DATE: June 18, 2014

AGENDA ITEM # 2

**TO:** Design Review Commission  
**FROM:** David Kornfield, Planning Services Manager  
**SUBJECT:** 14-SC-16 – 1064 Laureles Drive

Exterior Elevations  
Laureles Residence

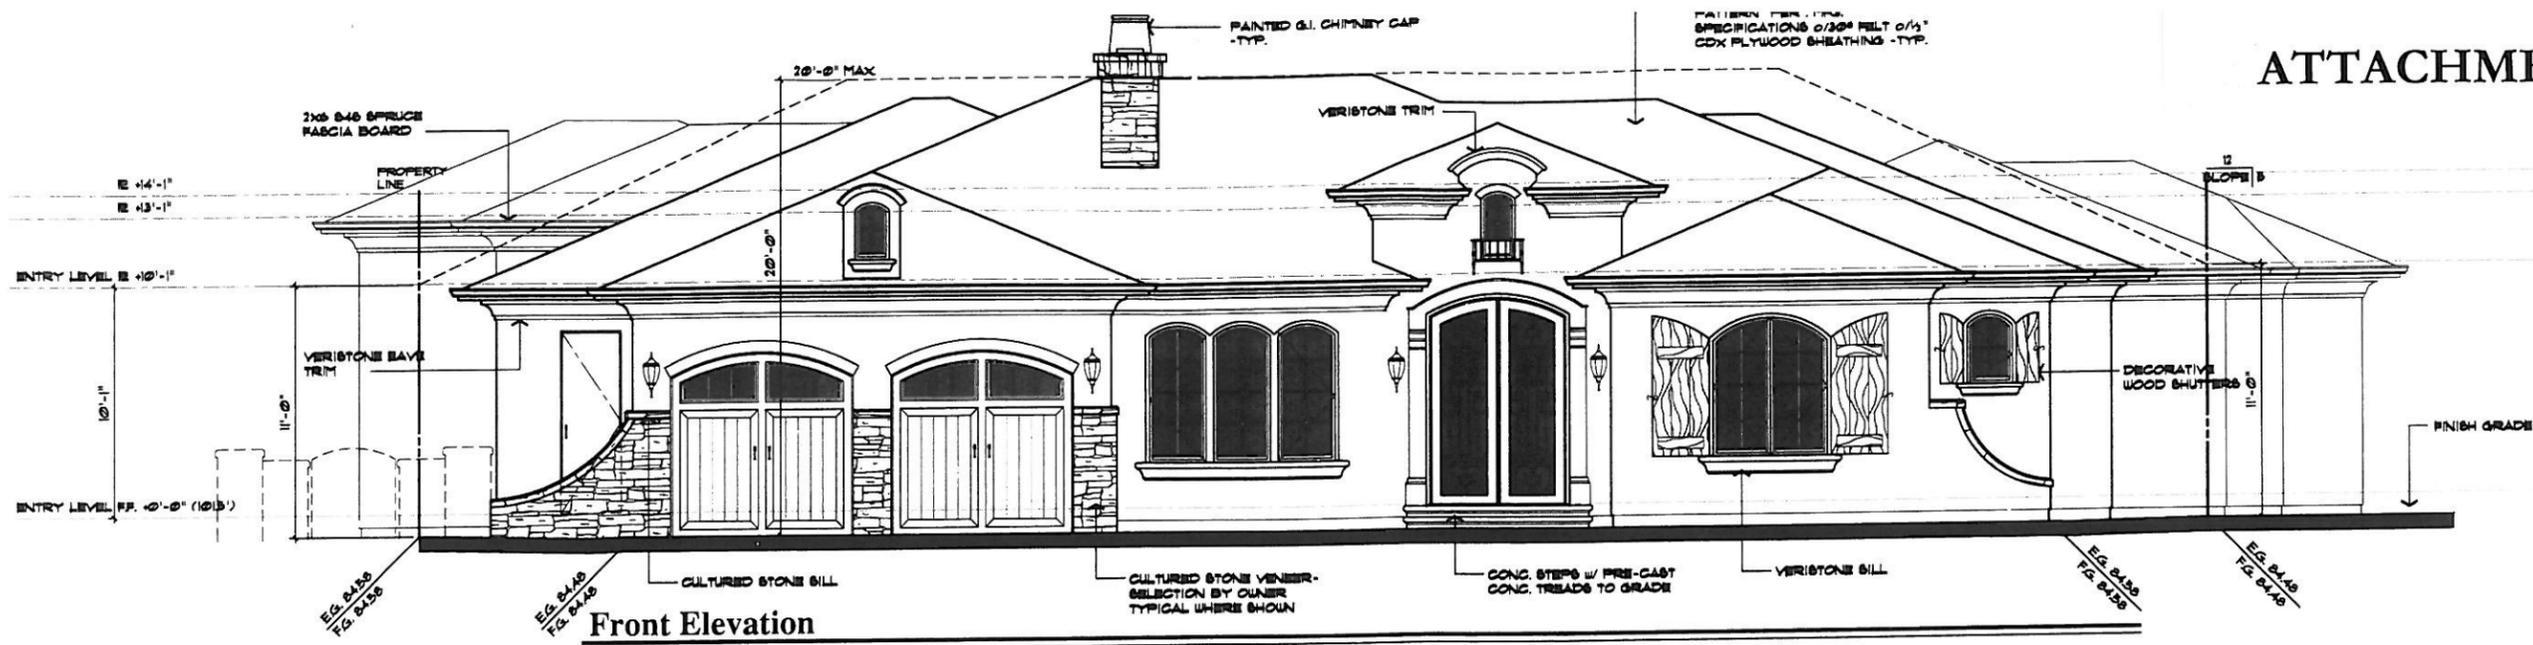
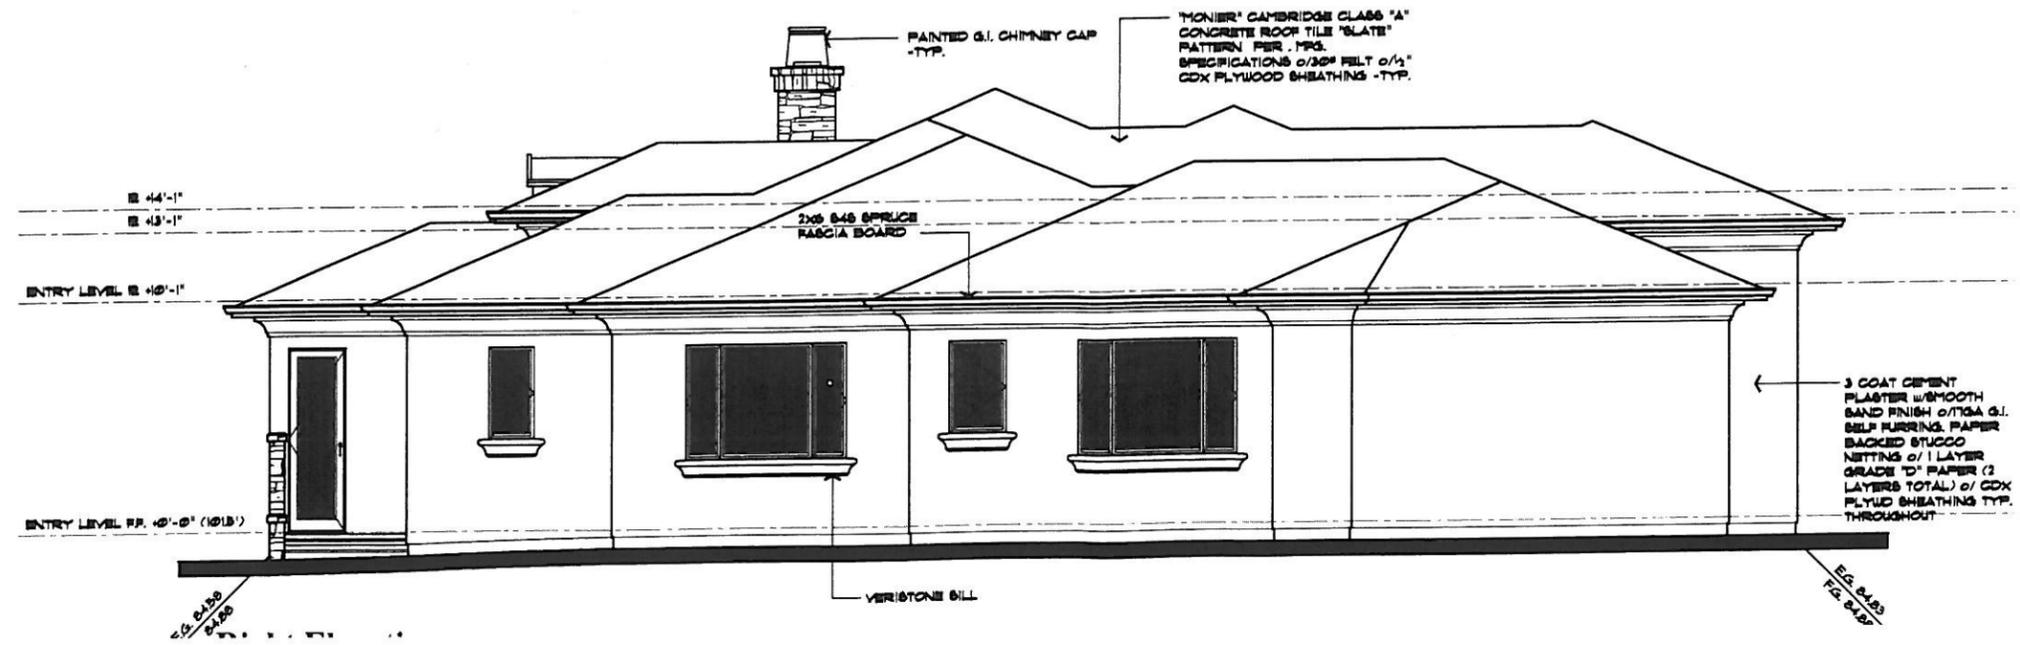
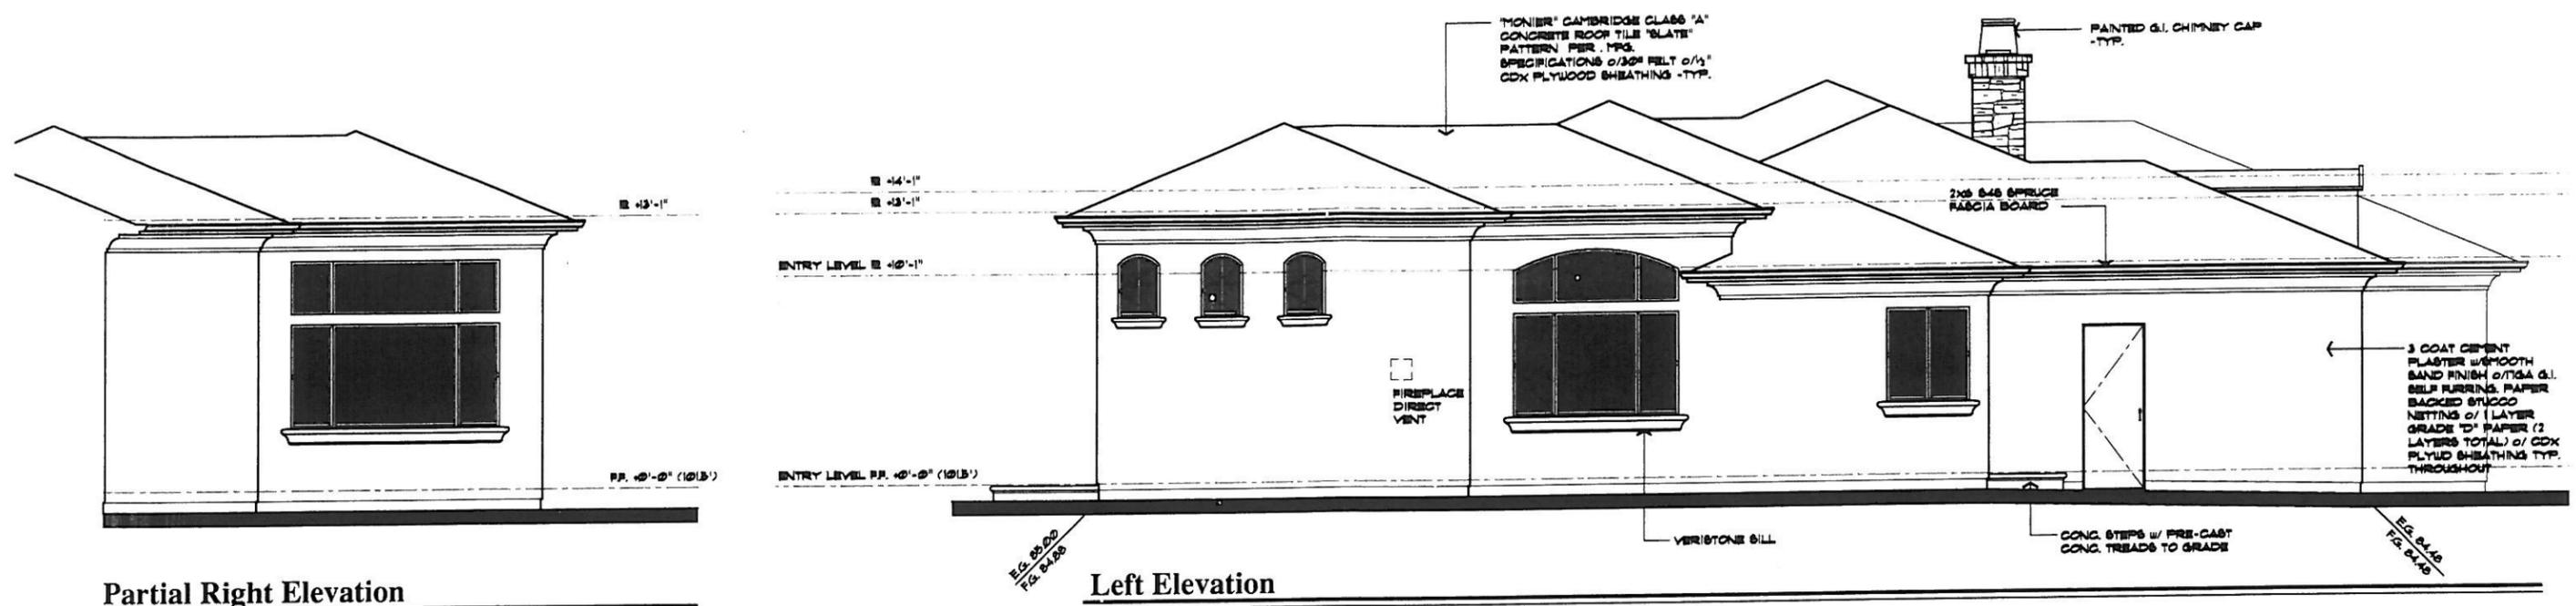
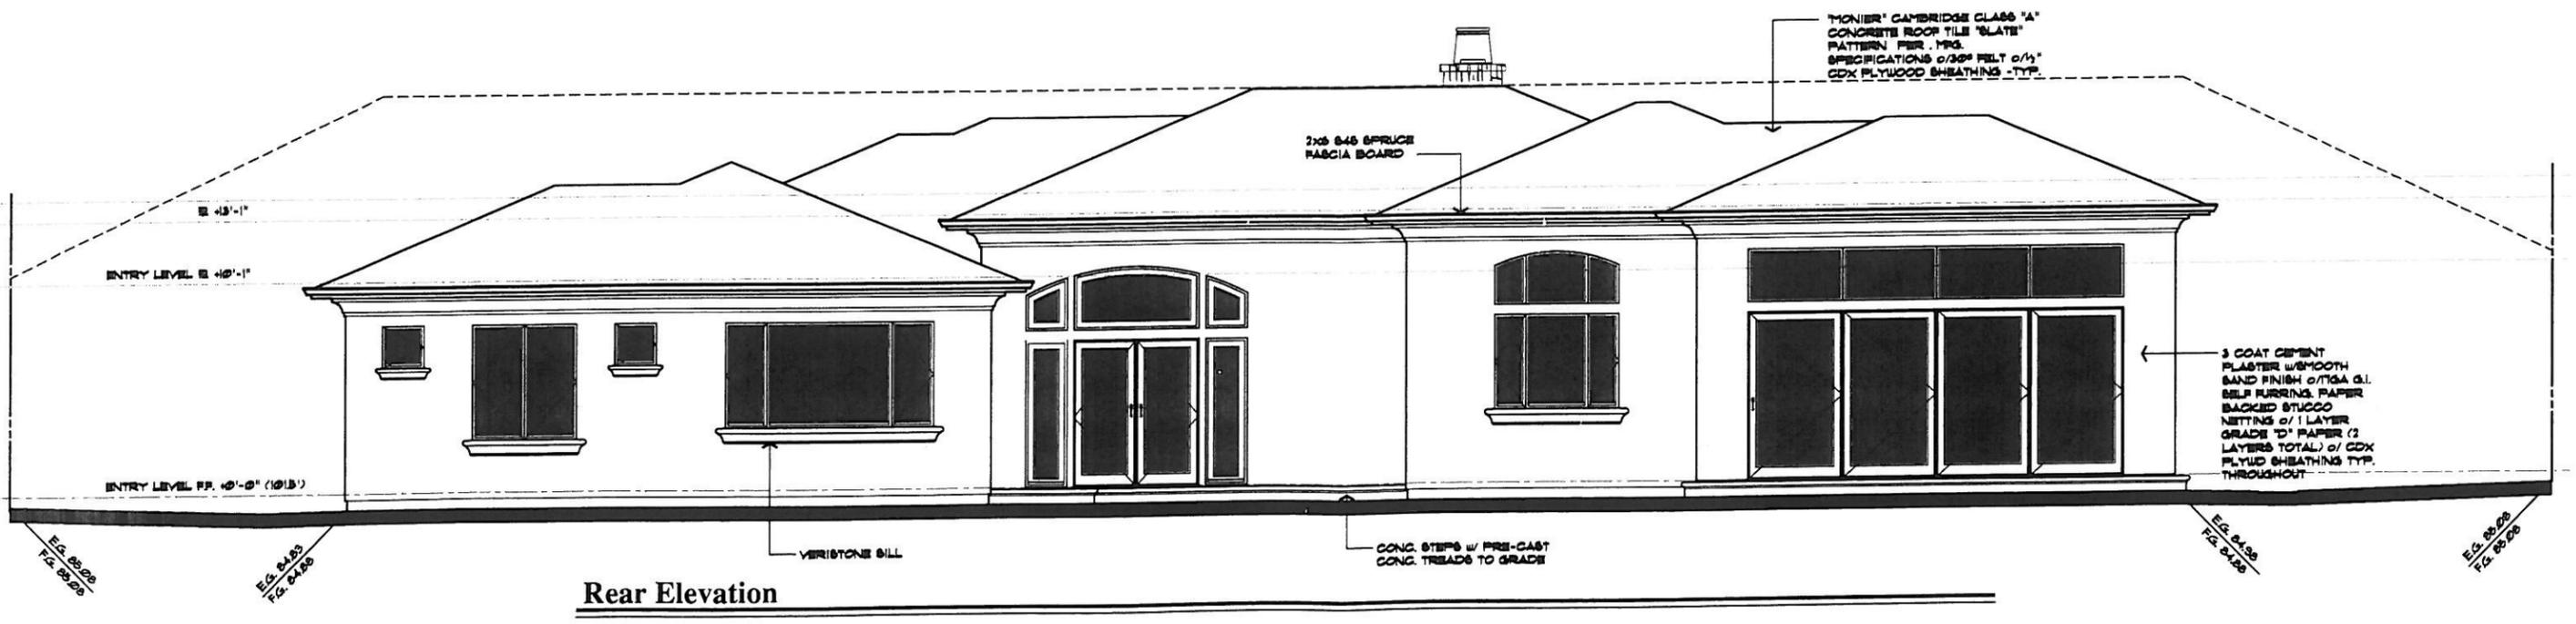
1. Reduce the height of the wall plates;
2. Simplify the wall and roof forms; and
3. Simplify the amount of design elements.

1. Lowered the roof and wall heights of the garage and laundry room elements by one foot (Front and Left Elevations);
2. Lowered the entry element by one foot (Front Elevation);
3. Lowered the wall and roof above the front bedroom by one foot, which removed one hip roof element (Front and Right Elevations, Roof Plan);
4. Removed the dormer above the garage (Front Elevation);
5. Removed the arched trim above the garage doors (Front Elevation);
6. Removed the faux balcony railing above the entry and the arched trim (Front Elevation);
7. Squared the window opening of the office window (Front Elevation);

8. Added stone to the low wall adjacent the office (Front Elevation); and
9. Added two 18-inch box-size screening trees in the northern, right side yard adjacent the taller bedroom walls (Landscape Plan).
